Tightening torque of the Yoke Seat and DIN Seat of the CALYPSO regulator.

Few pictures of deformed bodies due to an excessive torque:

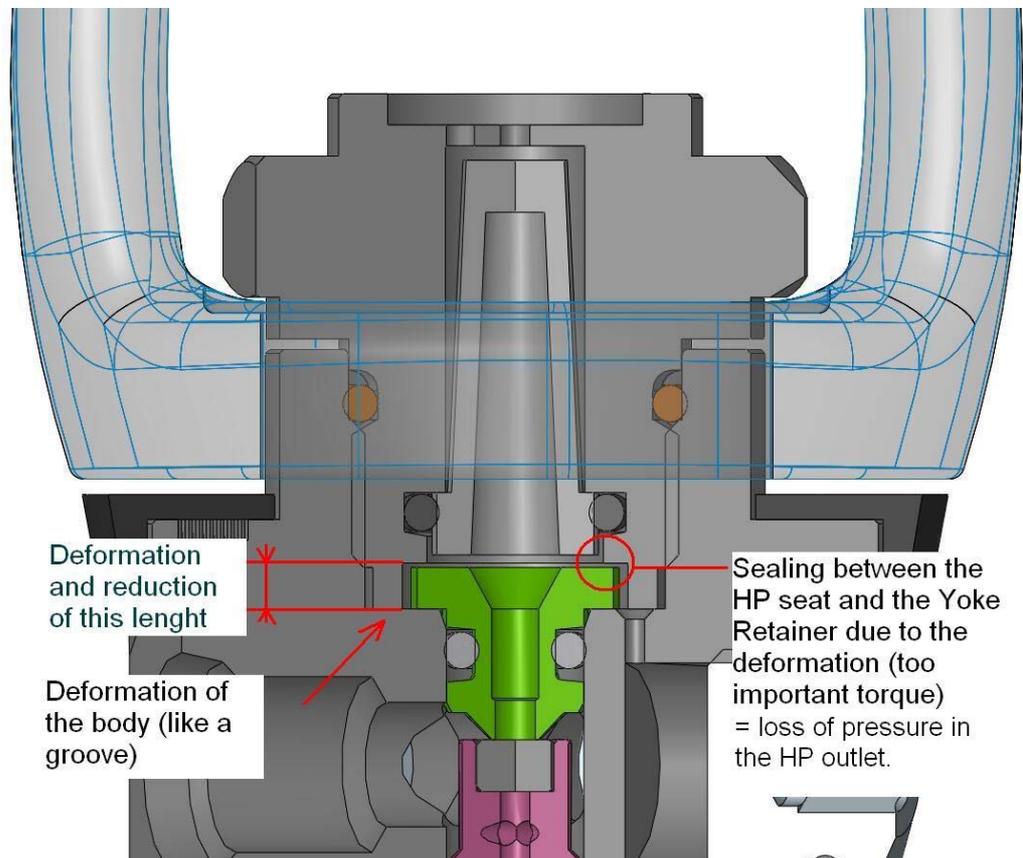
We were recently informed about several cases of lack of maintenance due to a too high torque applied on the Yoke Seat 125716 (or DIN Seat 125720) when tightened on the CALYPSO first stage body 125718.

Indeed, an excessive torque deforms the parts between them, and causes the loss of pressure in the HP outlet of the first stage.

A high torque can produce warping or components breaking when tightening or under pressure

The torque recommended by Aqua Lung is 25 N.m.

A torque wrench must be used to apply the torques recommended in the technical manuals.
